**RFP# 4237 - Addendum #1  
Roof Replacement  
Caudle Park Elementary**

# CAUDLE PARK SCHOOL ROOF REPLACEMENT

35 MCGEE DRIVE  
LOWER SACKVILLE, NS B4C 2J1  
ISSUED FOR ADDENDUM 01

**7 PARAPET AT ROOF B (EXISTING)**  
 A-501 SCALE: 3" = 1'-0"

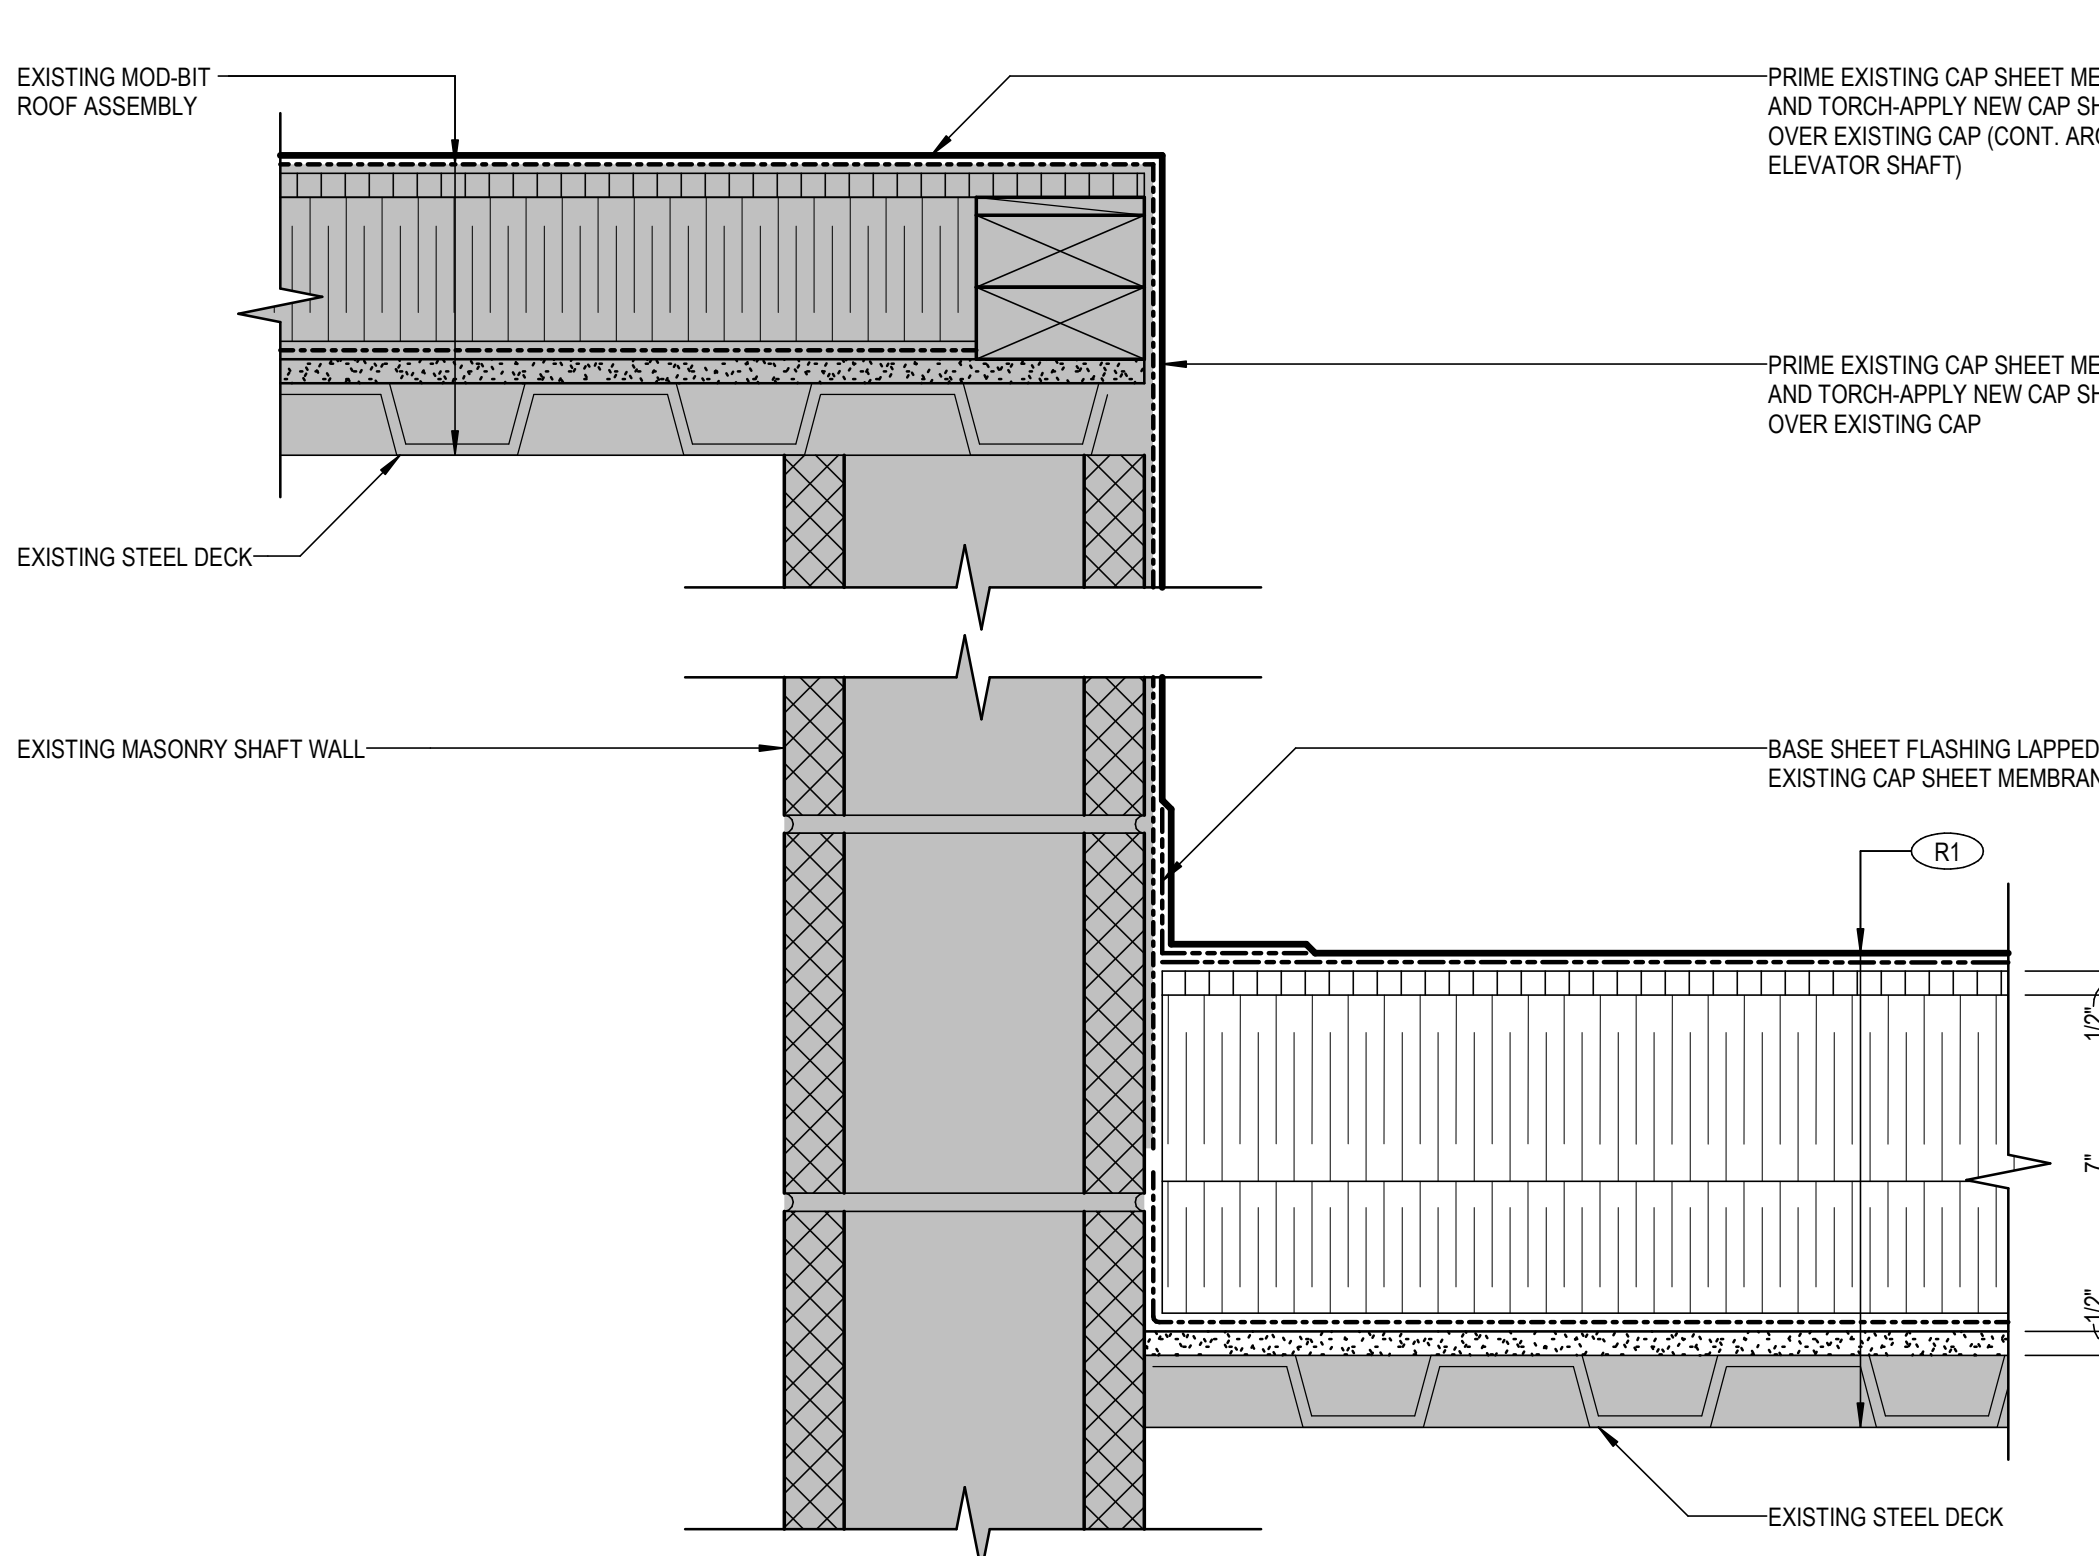
- .1 Delete Detail 5, 'Roof Drain at Sloped Structure at Roof A'.
- .2 Re-number details, as indicated.
- .3 Detail 6, Parapet (Existing):
  - .1 Rename to read 'Parapet at Roof A' and revise as indicated.
- .4 Detail 7, Parapet at Roof B (New):
  - .1 Delete detail and replace with 'Parapet at Roof B (Existing)'.
- .5 Detail 8, Parapet at Roof A (New):
  - .1 Revise as indicated.
